XC2200M Derivatives

16/32-Bit Single-Chip Microcontroller
with 32-Bit Performance

Errata Sheet

V1.6 2013-06

Figure 1 Context Switch with Pointer Passing in R15

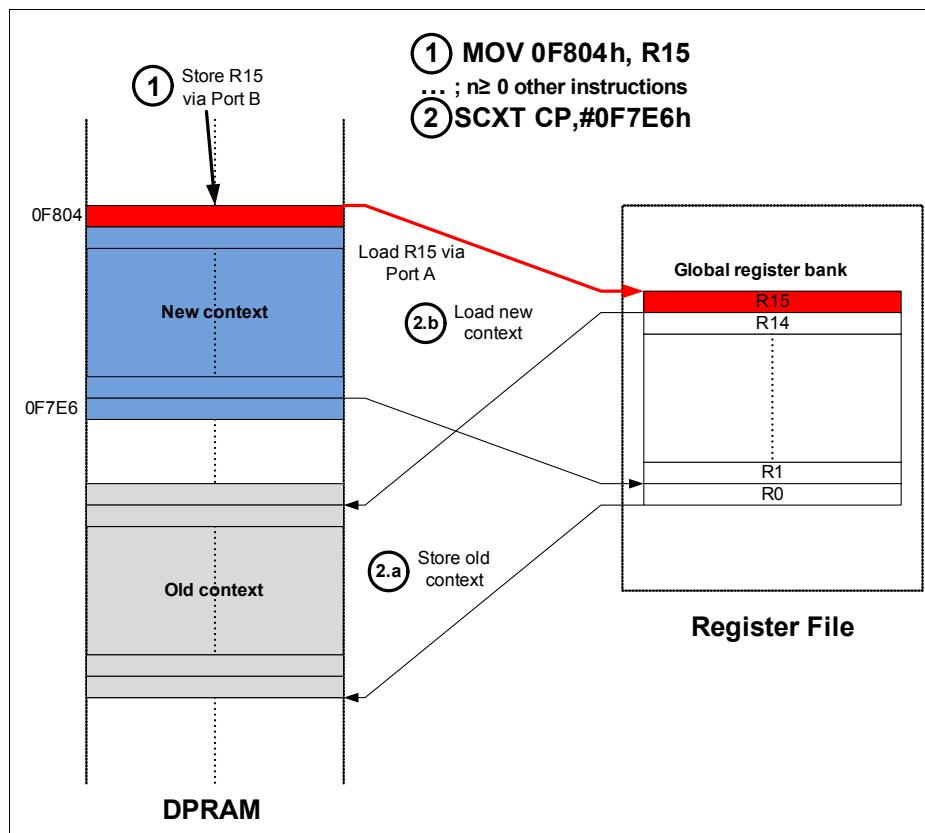
Scenario 1 (Context Switch)

In this scenario, the problem may occur under the following sequence of conditions (all conditions must be met):

1. L_1 and/or L_2 are located in the DPRAM in an area that is used to store the context of a global register bank, and

2. An explicit software write operation (i.e. no context switch) to L_1 and/or L_2 is performed, and
3. The Context Pointer (register CP) is modified (e.g. by MOV/POP/SCXT CP, ...) in one of the following instructions, leading to a context store (old context) and a context load (new context) of the global bank into/from DPRAM, and
4. One of the General Purpose Registers Rx with an odd register number x ($x = 1, 3, \dots, 15$) is loaded from locations L_1 or L_2 .

In this case, the contents of Rx may be incorrect.

This scenario may typically occur at the beginning of interrupt routines when a GPR (e.g. R15 used as user stack pointer) is saved into the new GPR context in DPRAM, as shown in the following **Figure 1**.

Workaround (Scenario 1)

- On **assembler** level, do not perform a context switch of the global register bank in case locations in the DPRAM corresponding to the location of a register Rx with an odd register number are written by software (see example for critical scenario in [Figure 1](#)).
- With the **compiler** of the TASKING VX-toolset, do not use the `__registerbank(...)` function qualifier to define a **global** register bank.
- With the **compiler** of the “Classic” TASKING C166/ST10 toolset, no workaround for this scenario is required (see analysis above).
- With the **compiler** of the Keil C166 toolset, no workaround for this scenario is required (see analysis above).

Figure 2 Critical application reset sequence

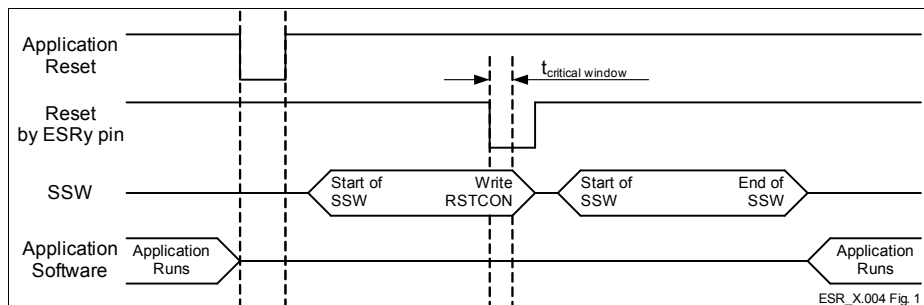
ESR_X.004 Wrong Value of `SCU_RSTCONx` Registers after ESRy Application Reset

`SCU_RSTCONx` registers are reset only by Power-On, but they may be wrongly affected after a second application reset requested by an ESRy pin. This may lead to the `SCU_RSTCONx` register values being set to zero, which could unexpectedly disable reset sources within the user application. The conditions which lead to this behavior are:

1. First, an application reset by SW (software), CPU (Central Processing Unit), MP (Memory), WDT (Watchdog Timer) or ESRy (External Service Request y) occurs.
2. Following this, an application reset on an ESRy pin occurs.
3. If the above mentioned ESRy reset occurs during a critical time window of the SSW (startup software), then it's possible that the application will operate with the wrong `SCU_RSTCONx` register value. The critical time window occurs when the SSW is writing the `SCU_RSTCONx` registers, and at the same time, the ESRy reset request is processed by the reset circuitry. The width of this critical window $f_{\text{critical window}}$ is less than 13 cycles.

- Initialize `SCU_RSTCONx` registers by user software after any reset, or
- assure that a second application reset request with an ESR pin does not occur during the critical time window.

Figure 3 Example for a Slow Input Signal

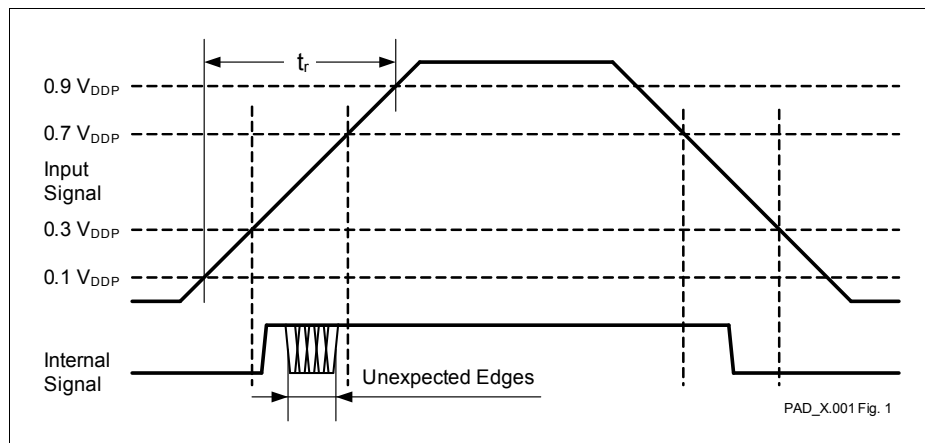
PAD X.001 Additional Edges in the Input Signal

The digital input- and I/O-pins are designed using Schmitt trigger input structures with hysteresis. Even with this structure, it is possible that very slow

rising edges may generate spikes, resulting in unexpected additional edges at the input signal.

The next picture **Figure 3** is an example for a slow input signal, with spikes shown on the slow rising input signal.

The first rising edge in **Figure 3** of the internal signal is always valid. The edges which are marked with “Unexpected Edges” must be ignored.

Use rising edges with faster rising slope t_r than defined in [Table 11](#).

Figure 4 Falling Edge Detection Approach

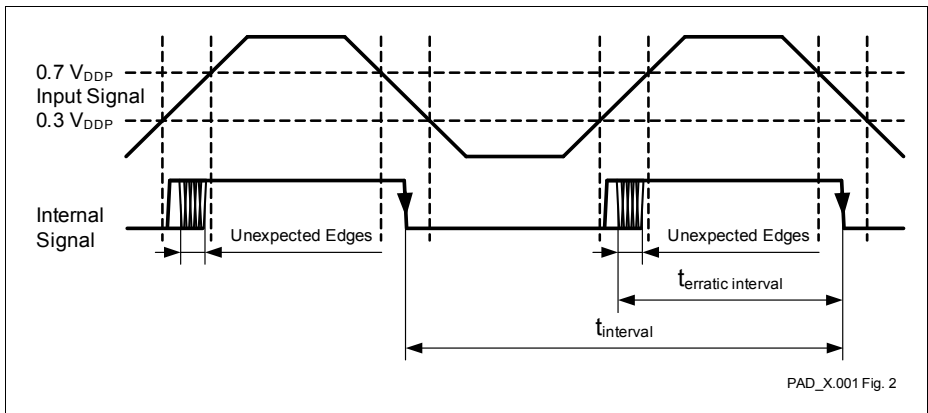
4.1 Falling Edge Detection Approach

1. Measure the time interval since the last interrupt (shown as in t_{interval} in [Figure 4](#) below) and check that it is in the expected time range.
 In the example, an erratic edge would cause the measured time interval $t_{\text{erratic interval}}$ to be approximately 50% of the expected value.
2. The state of the input pin that caused the interrupt could be read several times in the interrupt service routine and a majority decision made to check if the input pin really is at a low level to determine whether this is a genuine falling edge interrupt or whether the interrupt was triggered by a spike generated by a slow rising edge.

Only if 1) and/or 2) indicate that the edge was reliable, should the rest of the interrupt service routine be executed.

Figure 5 Rising Edge Detection Approach

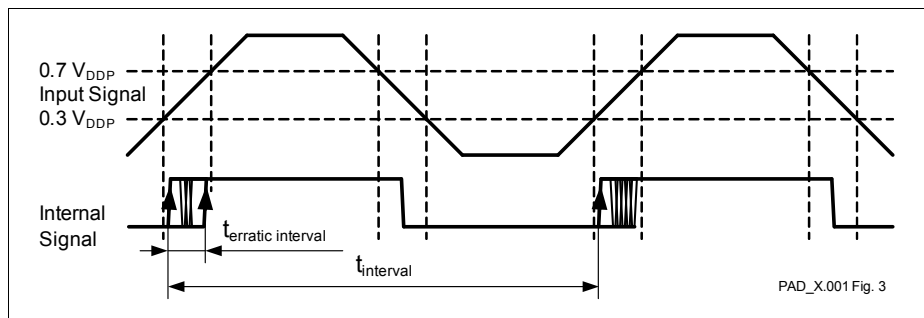
4.2 Rising Edge Detection Approach

In case of rising edge detection multiple interrupts would be generated when the spike occurs. The time interval since the last interrupt can be measured – if it is very small compared to the expected value, this would indicate a spike and the interrupt should be ignored.

If the time between the rising signal edge and the rising edge caused by a spike $t_{erratic}$ is less than the ISR service time, a workaround would be to clear the interrupt request (IR) flag before the return from interrupt is done. The clearing of the IR flag will avoid a further erratic interrupt.

The preferred solution for interrupt handling is to use the rising edge detection.

Figure 6 Rising Edge and Falling Edge Detection Approach

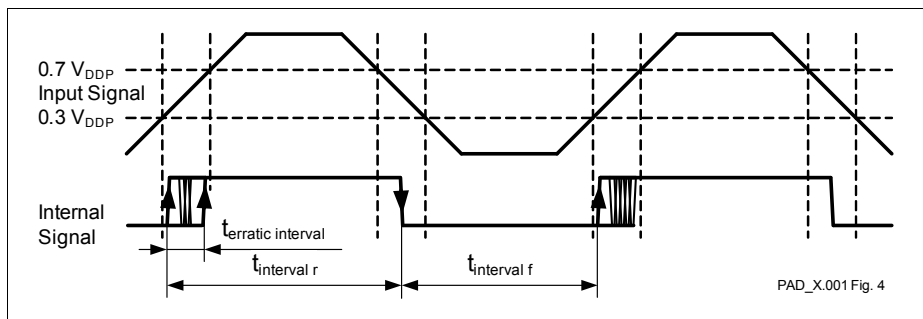
4.3 Rising Edge and Falling Edge Detection Approach

The rising edge detection workaround works also if both edges are used as trigger for interrupt and the following conditions are valid:

- $t_{erratic\ interval} \ll t_{interval\ r}$ and
- $t_{erratic\ interval} \ll t_{interval\ f}$

Figure 7 Alert Interrupt Behavior in case of Bus-Off

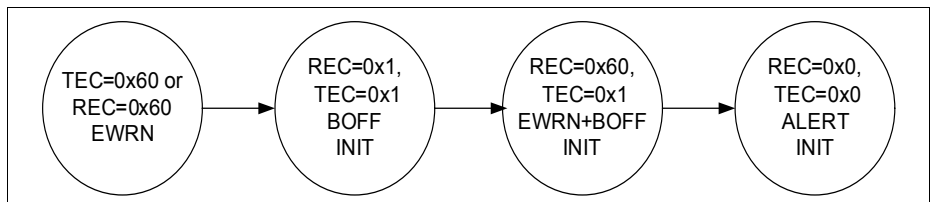
MultiCAN_AI.H007 Alert Interrupt Behavior in case of Bus-Off

The MultiCAN module shows the following behavior in case of a bus-off status:

Figure 8 Loss of Arbitration

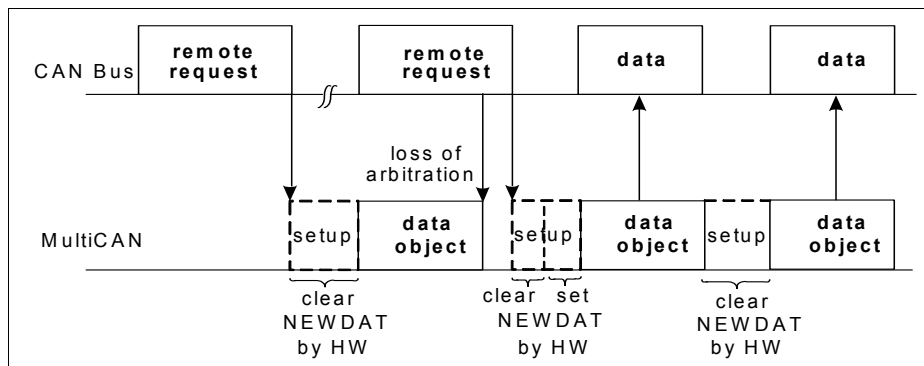
When the appropriate message object (data frame) triggered by the first remote frame wins the arbitration, it will be sent out and `NEWDAT` is not reset. This leads to an additional data frame, that will be sent by this message object (clearing `NEWDAT`).

There will, however, not be more data frames than there are corresponding remote requests.
